TRANS/WP.29/GRSP/2000/..
XX October 2000

PROPOSAL FOR DRAFT AMENDMENTS TO REGULATION NO. 21
(Interior fittings)

Transmitted by the Experts from Spain and Germany

FIGURE 1

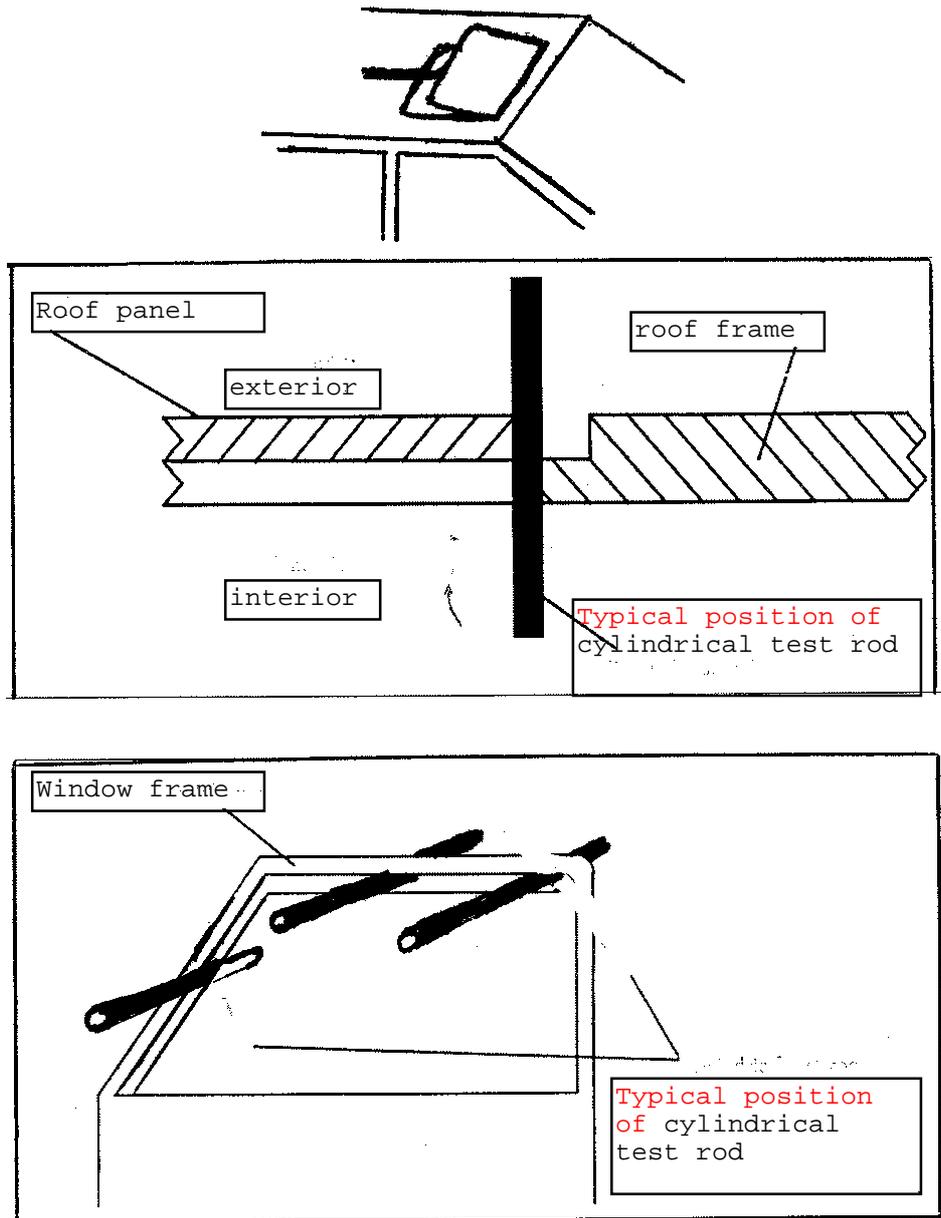
POSITION OF CYLINDRICAL TEST ROD IN THE OPENING ROOF AND WINDOW OPENINGS

TYPICAL POSITIONS OF TEST RODS

FIGURE 2

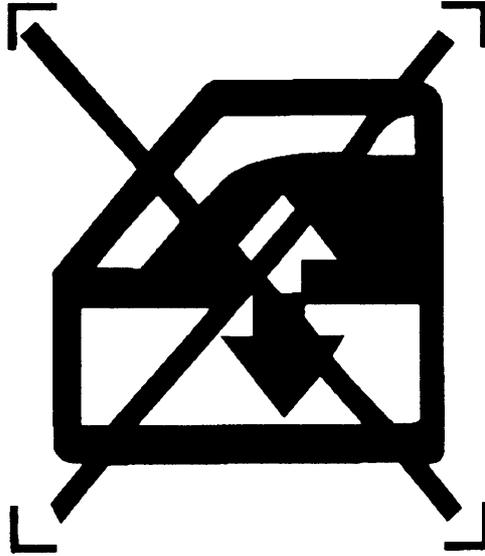
The driver-controlled switch shall be located so as to minimise any accidental manipulating. It shall be identified by the symbol shown in **Annex 9, Figure 2** ~~Appendix 4~~ or an equivalent labelling, for example, according to ISO 2575: 1998.
